Service Bulletin

Bulletin No.: 23-NA-165

Subject: Vehicle Will Not Lock and Unlock (Loss of Active Functions) Crank or Start (Loss of Passive Functions) with DTC P0513 Set

6430395

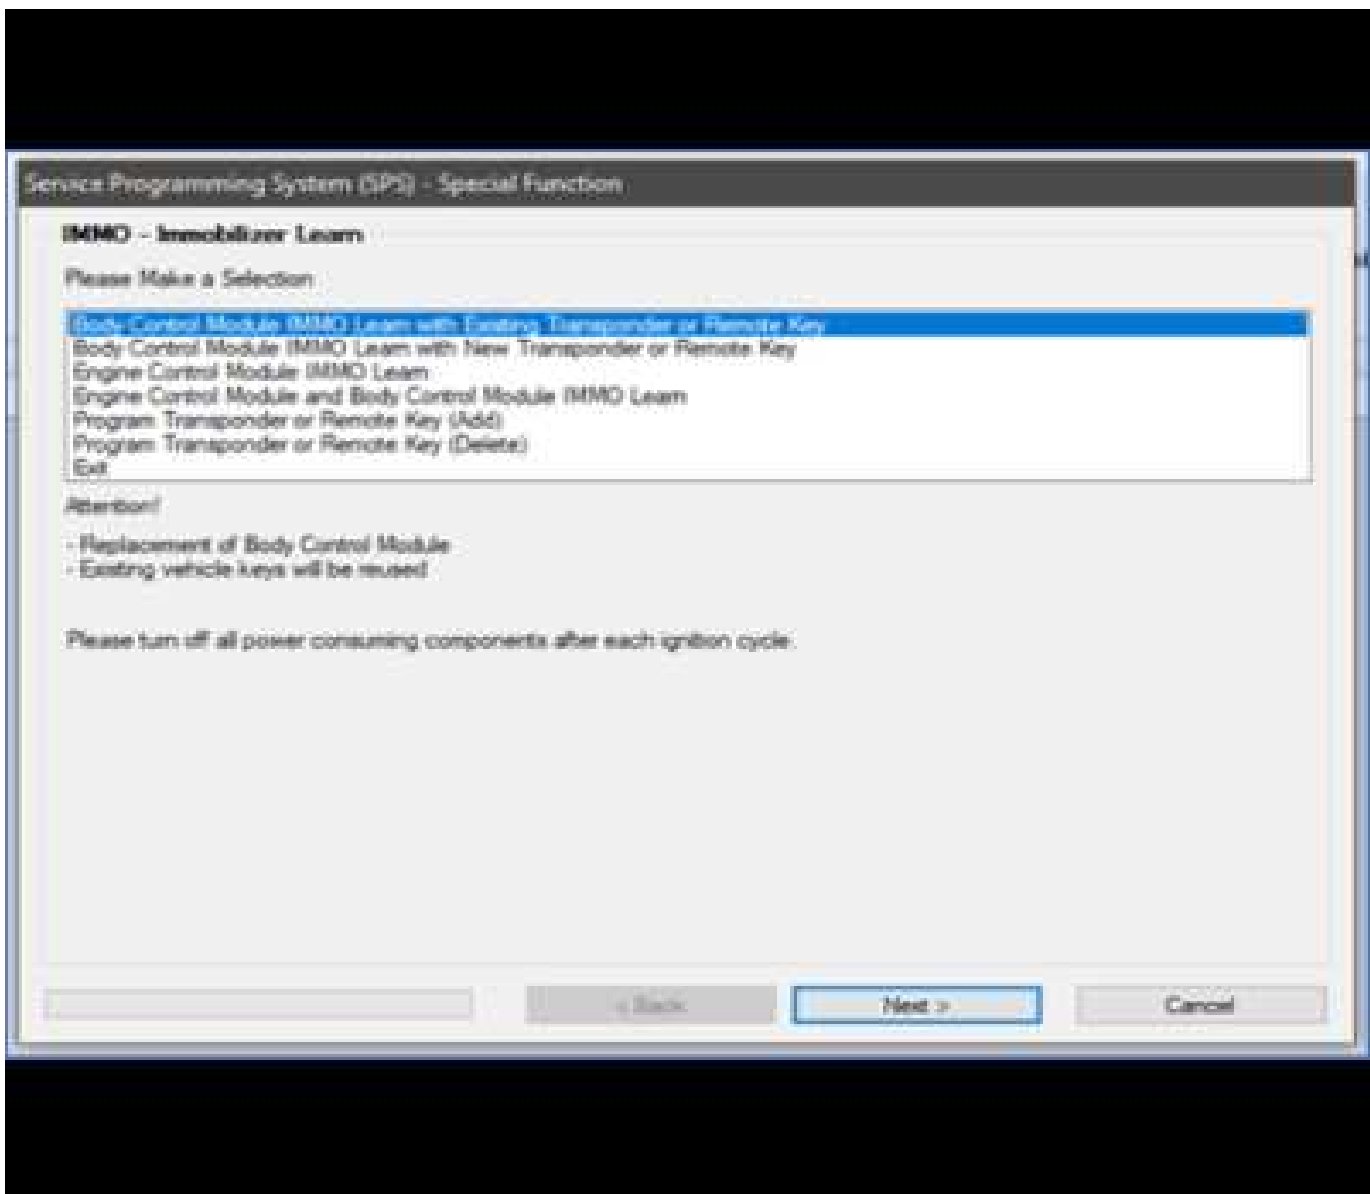
1. If no immobilizer learn was performed, verify there are no immobilizer DTCs set in the K9 Body Control Module. If any codes are set, please refer to service information.
2. From SPS Supported Controllers, select K9 Body Control Module "Programming A Per Bulletin 23-NA-163 and 23-NA-165 Only."

Version	2
Modified	Released September 18, 2023 Revised November 15, 2023 – Updated Step 2 and 5 programming sequence title and graphics.

6430396

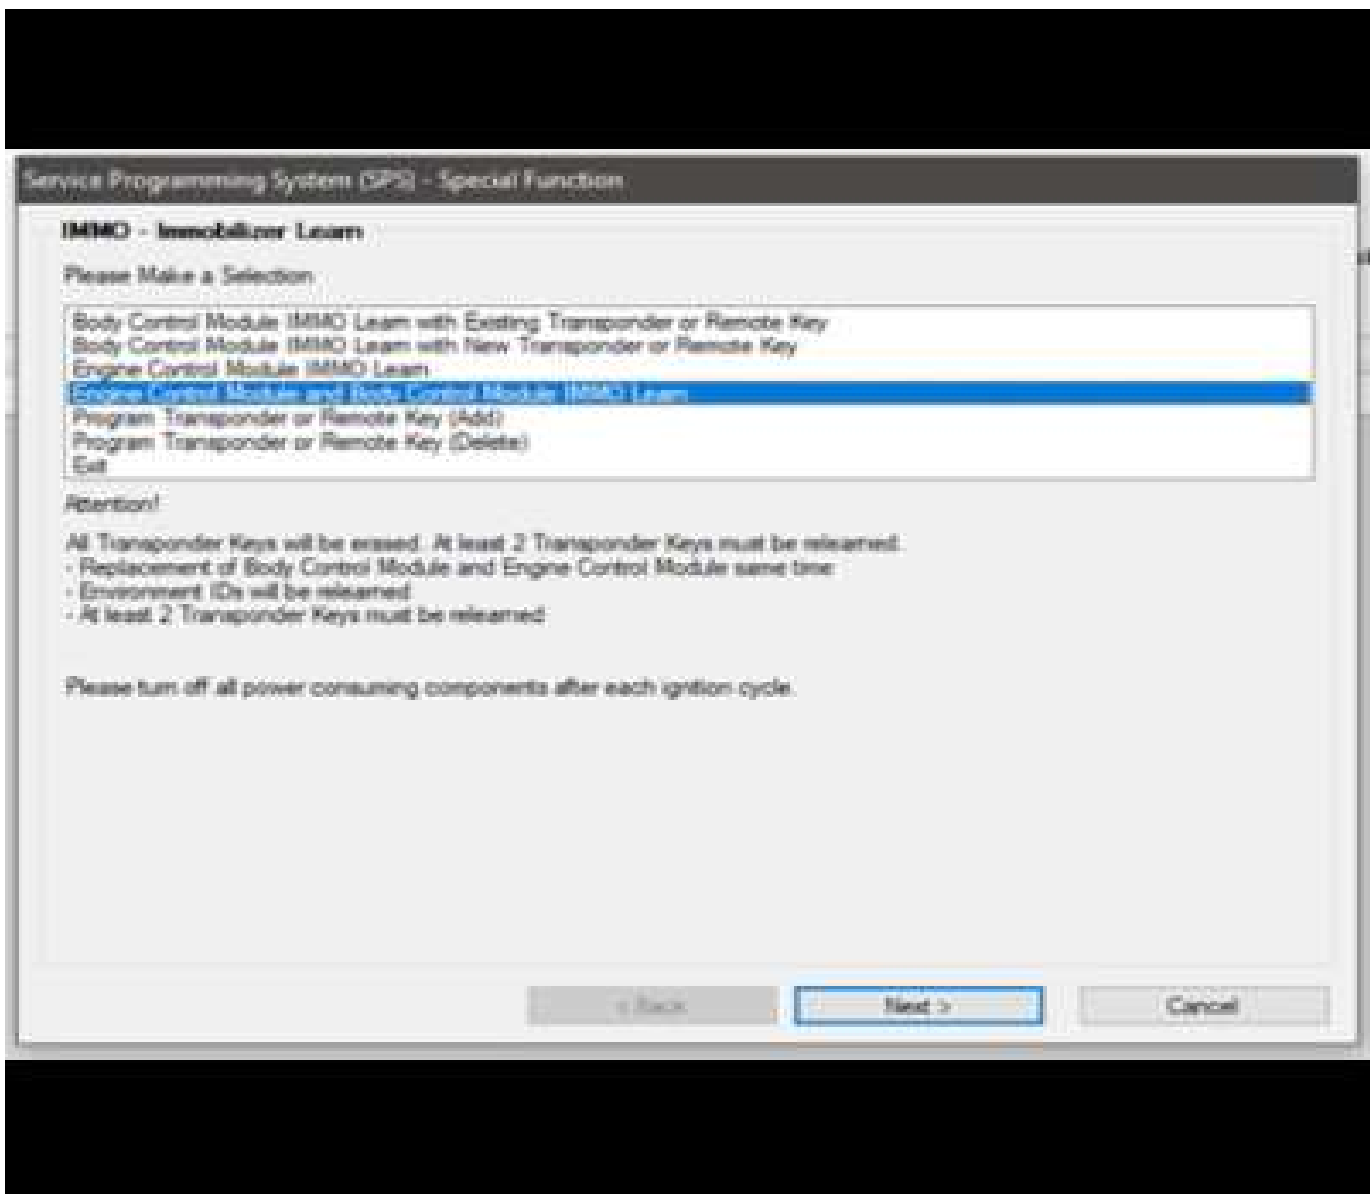
5. From SPS Supported Controllers, select K9 Body Control Module "Programming A Per Bulletin 23-NA-163 and 23-NA-165 Only."
